Addendum No 1:
PROPOSED COSTCO OFFICE EXPANSION,
415 WEST HUNT CLUB ROAD
CITY OF OTTAWA
TRANSPORTATION IMPACT
ASSESSMENT REPORT (June 20th, 2024)

The following Addendum document was produced to provide refinements to the above TIA document to account for alterations done to the Site Plan

DRAWING TITLE: SITE PLAN

Addendum No A-1:
PROPOSED COSTCO OFFICE EXPANSION,
415 WEST HUNT CLUB ROAD
CITY OF OTTAWA
TRANSPORTATION IMPACT
ASSESSMENT REPORT (June 20th, 2024)

Updated Site Plan (November 2024)

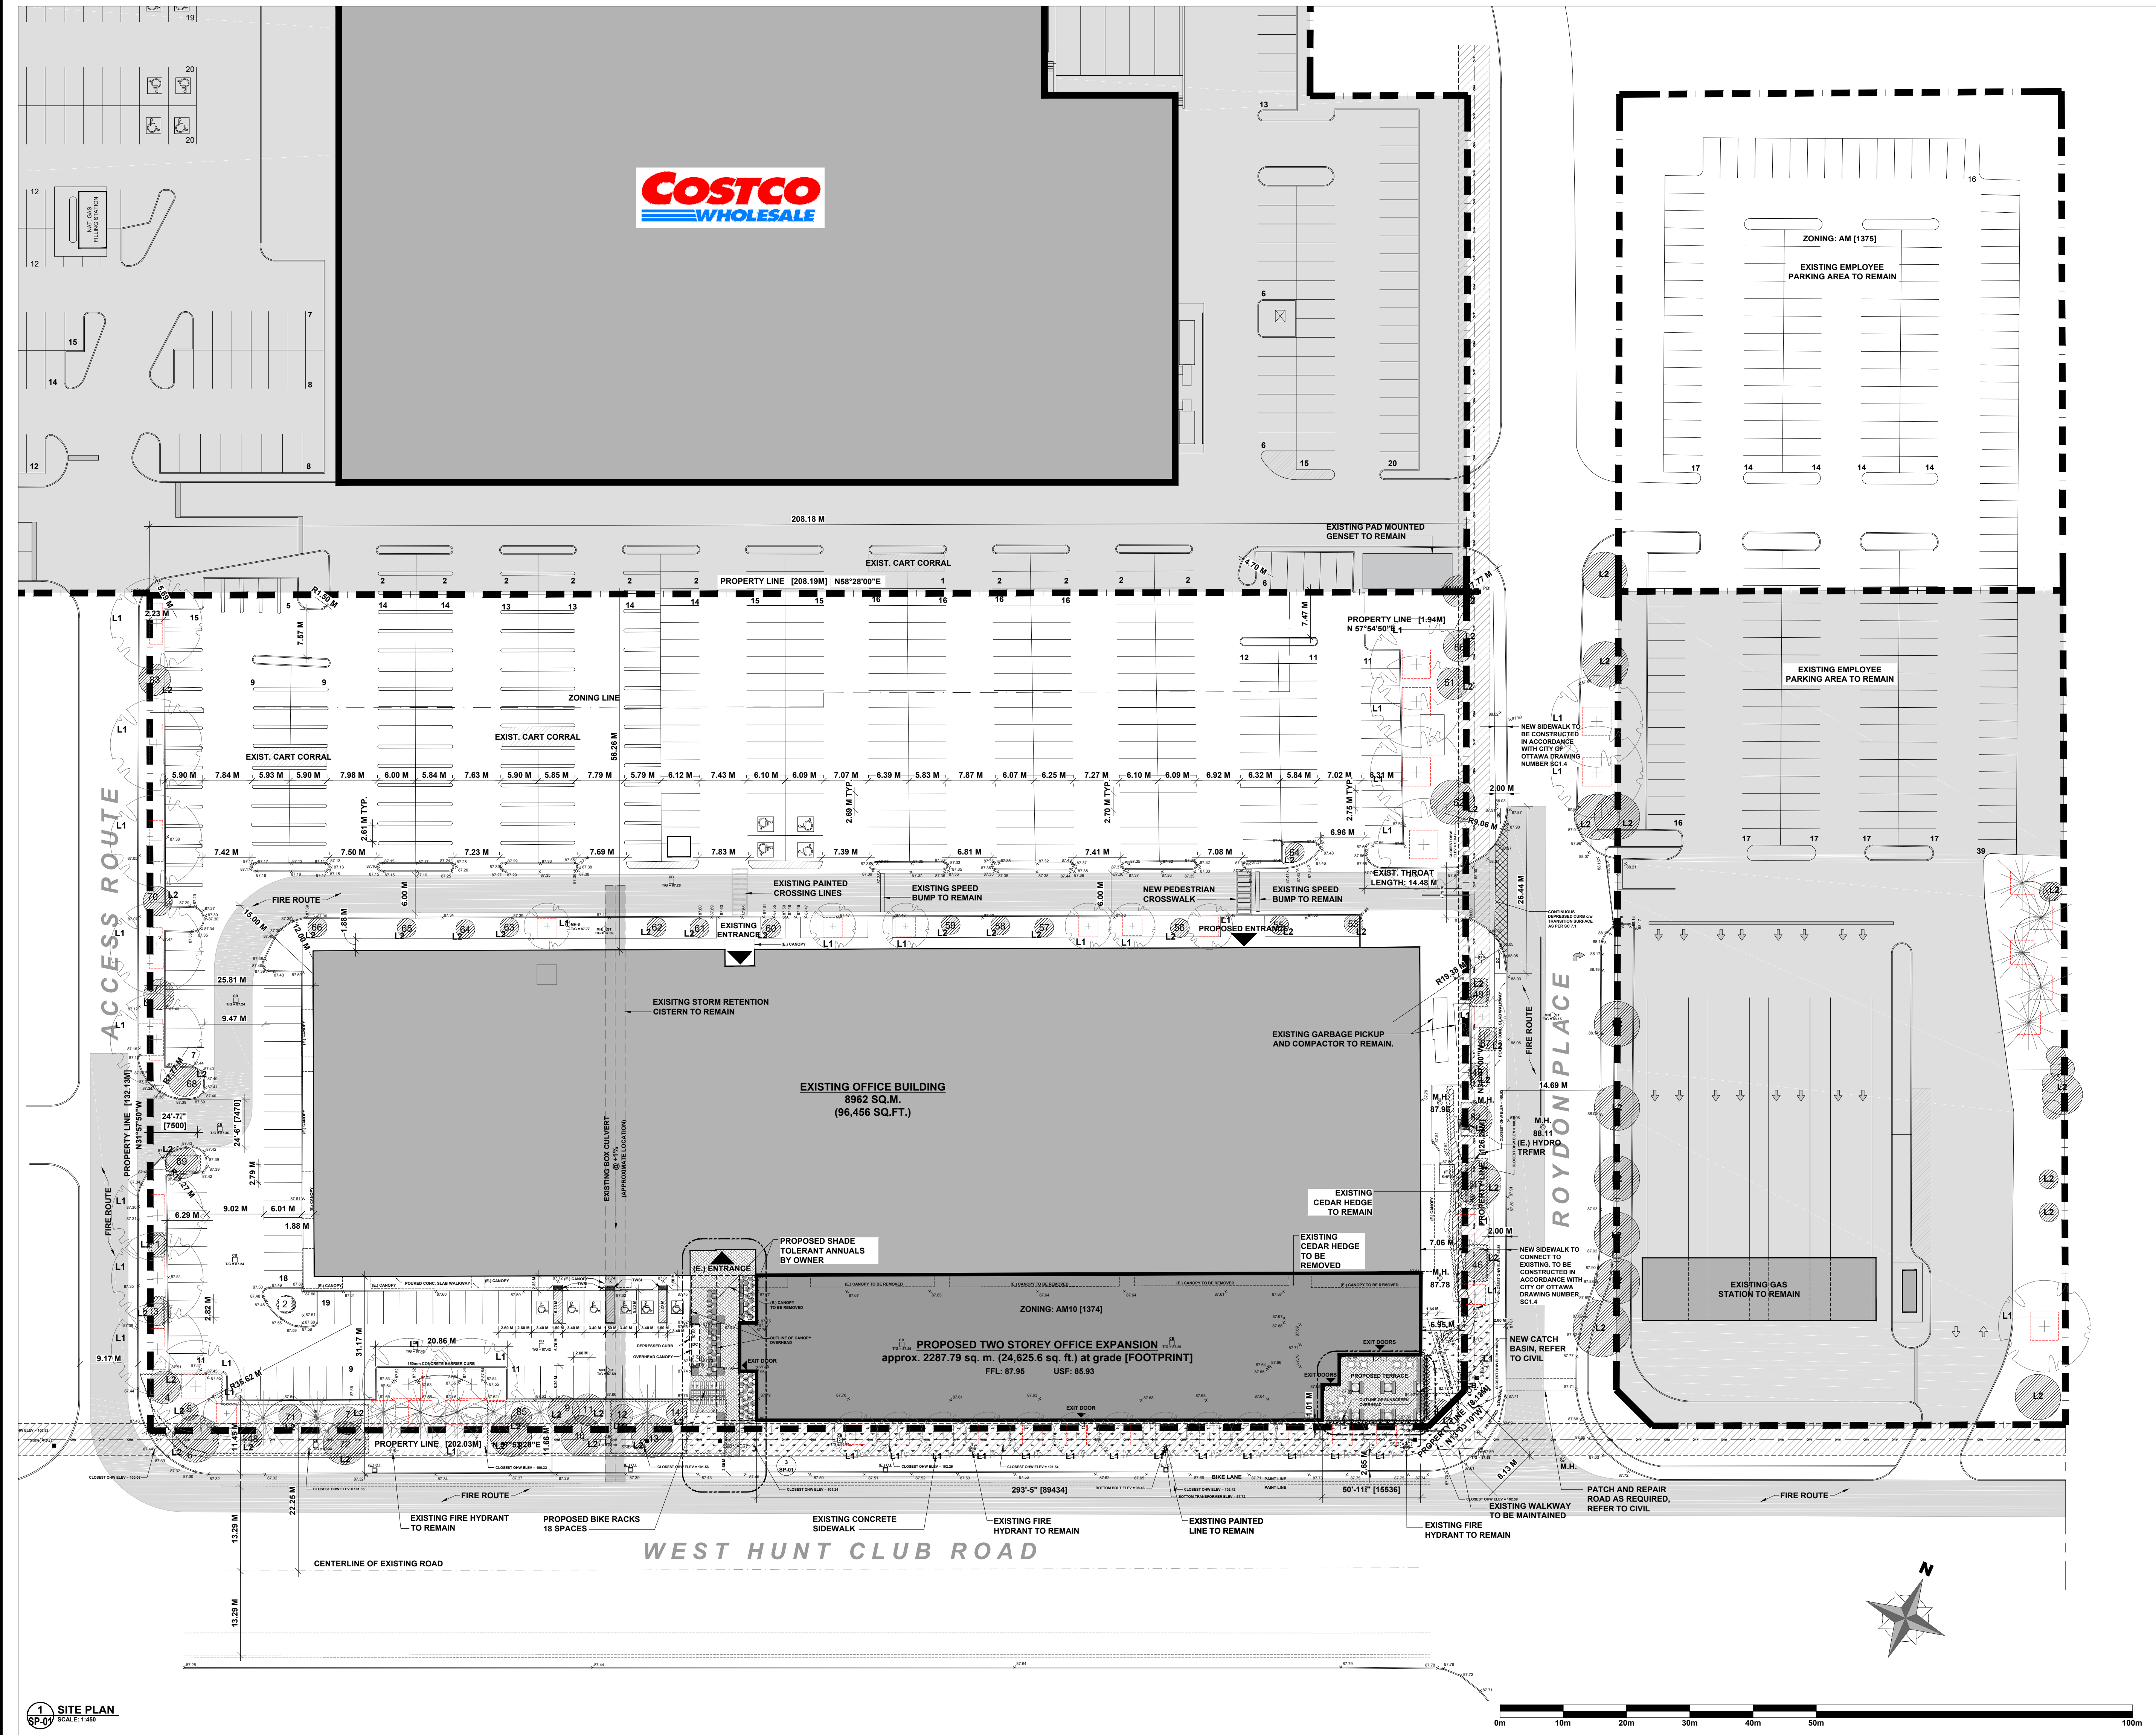
Following the submission of Addendum 1, an additional round of comments was received from City staff. A new site plan was produced on November 25th, 2024 to account for these comments.

- The sidewalk width along Roydon Place was reduced from 2.55 meters to 2.0 meters;
- The number of total available parking stalls was reduced from 602 to 599; and
- The location of the barrier-free parking at the new proposed entrance was changed from three on either side of the lane way to all six barrier-free parking spaces lining the south wall of the existing building.

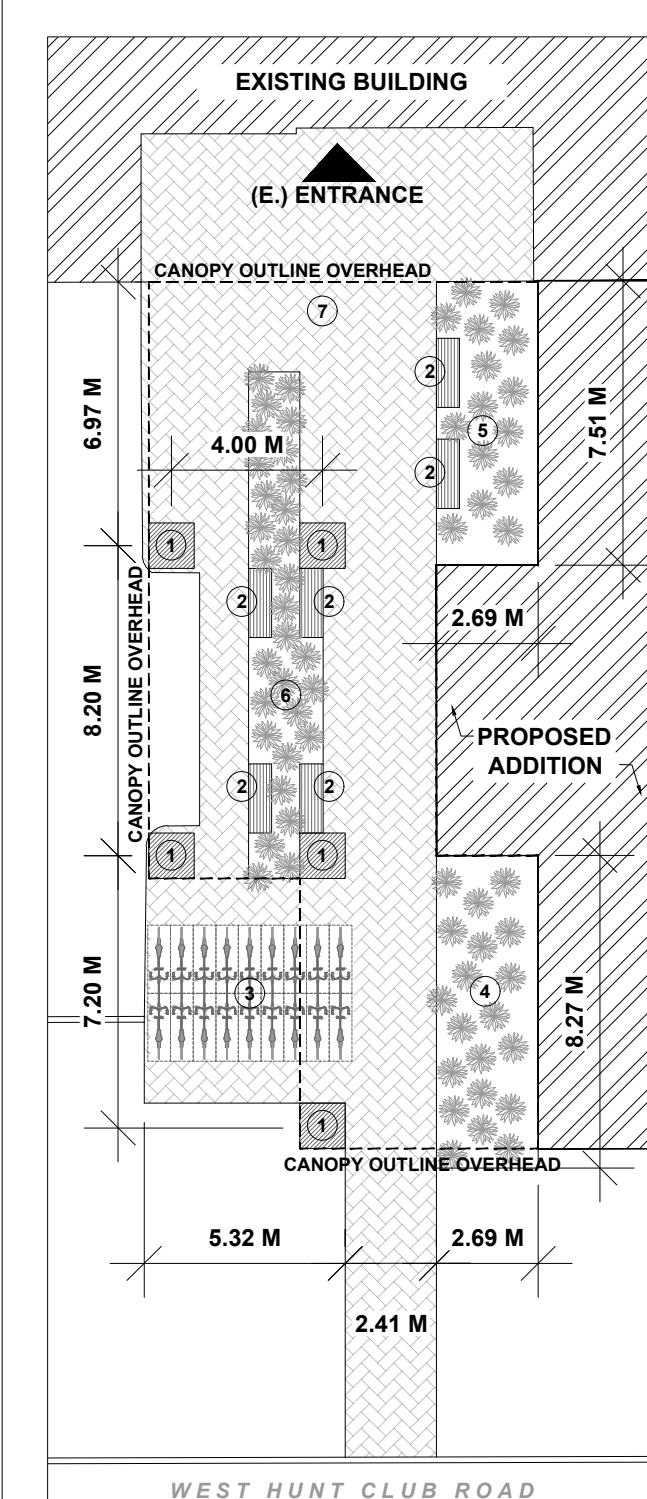
#7 - IDENTIFY LOCATION OF SNOW STORAGE

#7 - SNOW TO BE REMOVED AND STORED OFF-SITE
